# Mid-Breton Sound Sediment Diversion Independent Technical Design Review

FINAL REPORT

JANUARY 12, 2016

THE COASTAL PROTECTION AND RESTORATION AUTHORITY OF LOUISIANA

Figure 2: Reproduction of Figure 8, Mid-Breton Sound Diversion Land Building

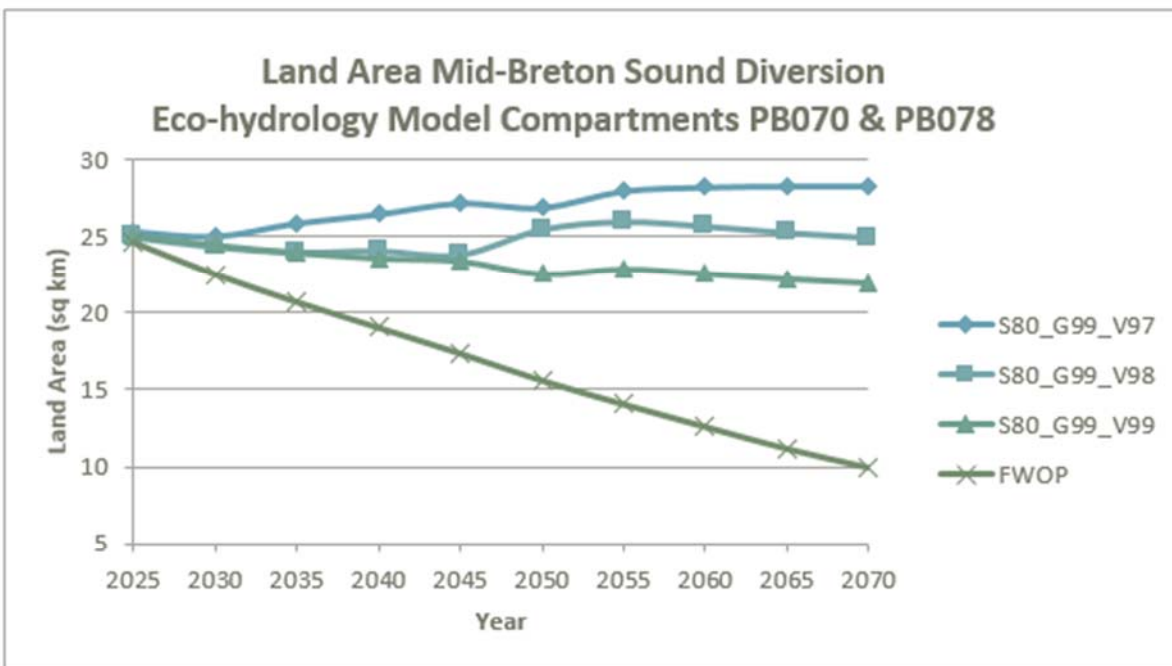
It is believed that insufficient justification has been provided for the selection of a nominal 35,000 cfs design discharge for Mid Breton, as it is noted that higher discharge rates would have higher SWRs. Furthermore, the March 10 2015, Water Institute's Draft Technical Memorandum with a subject of:

"Summarized Master Plan Model Output – TO30 (Mid-Breton Sediment Diversion)" Figure 8 (reproduced below as Figure 2) indicates moderate land building compared to the size of the Mid-Breton Sound Basin. Thus if the nominal 35,000 cfs discharge size was selected due to concerns that the receiving basin could not accept more sediment, then it is recommended that supplemental dredging be evaluated to promote sediment distribution in the receiving basin.

Figure 6. Model Development of Optimization 5 (Plan View with bathymetry) (Water Institute, 2013)

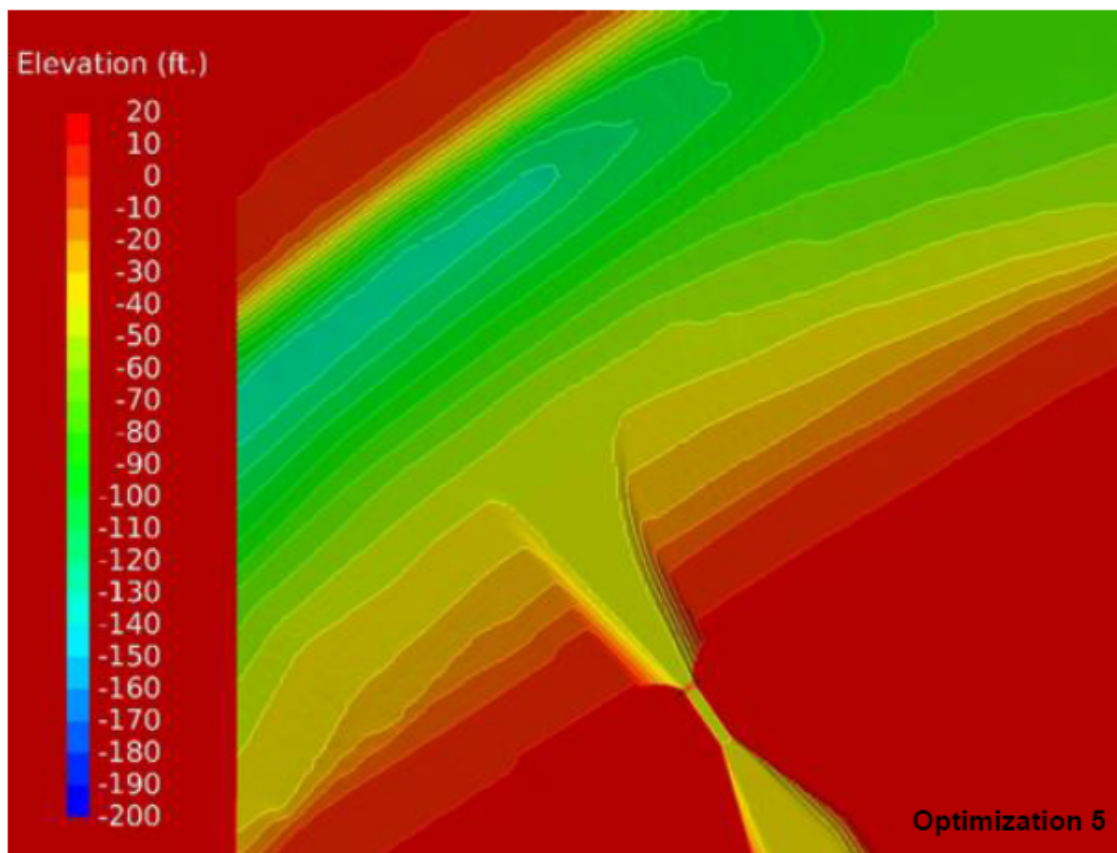
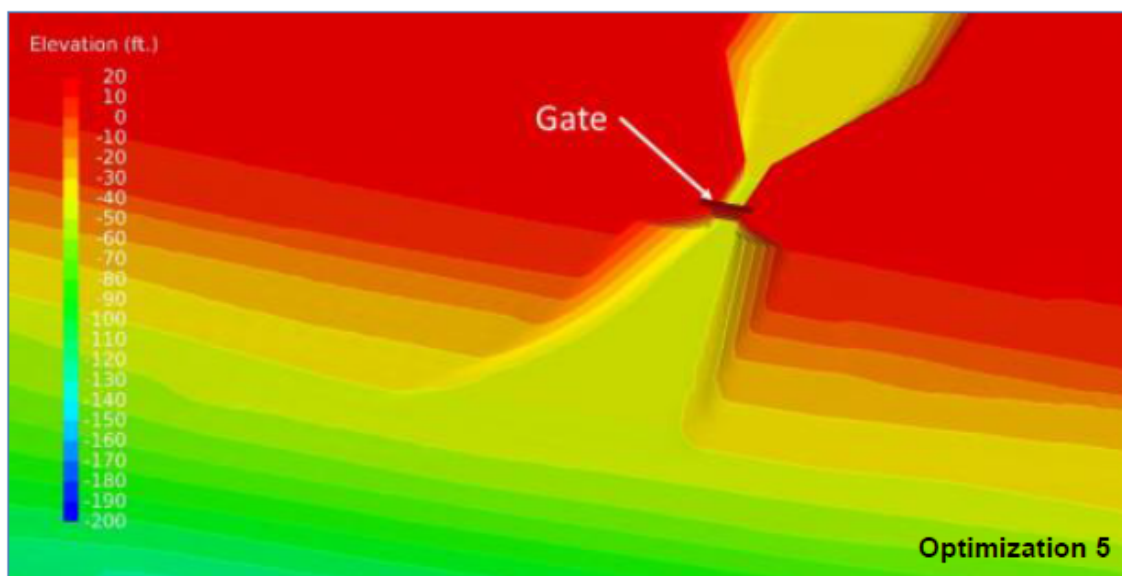
Figures 6 and 7 show that the hydraulic model for Optimization 5 had a uniform bathymetric elevation for both the intake and discharge channels. Figures 8 and 9 show the calculated bottom, and average, water velocities for the Optimization 5 for two dredged intake channel bathymetry layouts. Finally, Figure 10 is a table indicating that the Optimization 5 configuration has reasonable (but not optimized) calculated sediment discharge parameters.
